RotorSport UK Ltd Service Bulletin (Permit)

Title: Cavalon low-fuel sensor upgrade		
SB No.: 097 Iss1	Related documents MC No: None CCAR No.: None	Compliance Category: OPTIONAL or RECOMMENDED or MANDATORY
Applicability		
Aircraft type & model: Cavalon	Aircraft serial Nos. affected: RSUK/CVLN/001 to 012	
This form is the response from RotorSport UK Ltd either against a problem found in the product in service requiring a containment or rectification action, or as service information for aircraft modification incorporation. For help, contact RotorSport on 44(0)1588 650769, or email info@rotorsport.org.		
<u>Reason and overview of the Service Bulletin (cause of problem if known)</u>		
<p>Cavalon gyroplanes approved under AAN29345 have a low-fuel sensor consisting of a vertical brass tube with cylindrical plastic float that rises and falls with the petrol level inside the right fuel tank. At 5 litres or below a magnet in the float triggers a sensor in the tube to illuminate a warning light on the instrument panel.</p> <p>RSUK have been made aware of instances of intermittent flashing of the low fuel warning when it is known that the fuel level is above 5 litres. This SB describes a sim

DESIGN	18.06.13	RotorSport UK Ltd	
ENGINEER	18.06.13	Low fuel sensor (Cavalon)	
SCALE		PART NO:	REV:
		RSD7226	2
		SHEET	OF 1

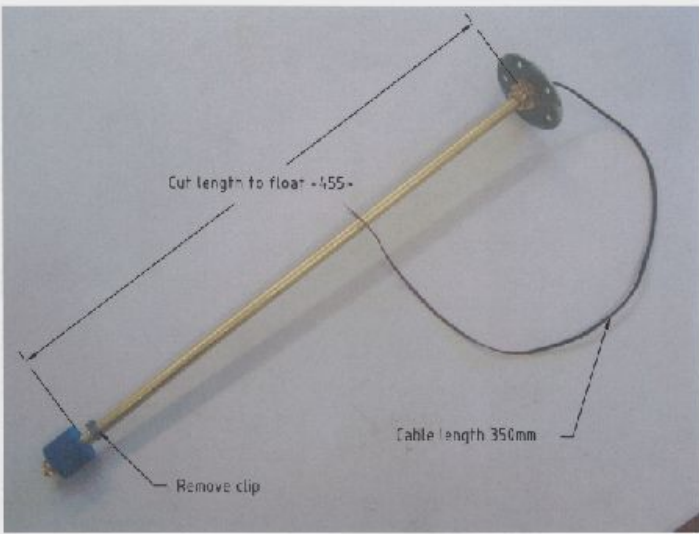
Note that the part number of the sensors is now RSD7226 Iss2.

REV	DATE	Change description	By	Check
1	1	First Issue	GB	18.06.13
2	2	Clip removed	GB	26.07.13

7. When surplus fuel has dried-off use a pair of pincers to cut-off the stainless-steel clip at the base of the sensor. Check that the split pin is secure and undamaged
8. Check that the float is undamaged and can rise to follow the true fuel level rather than its position being restricted by the clip.
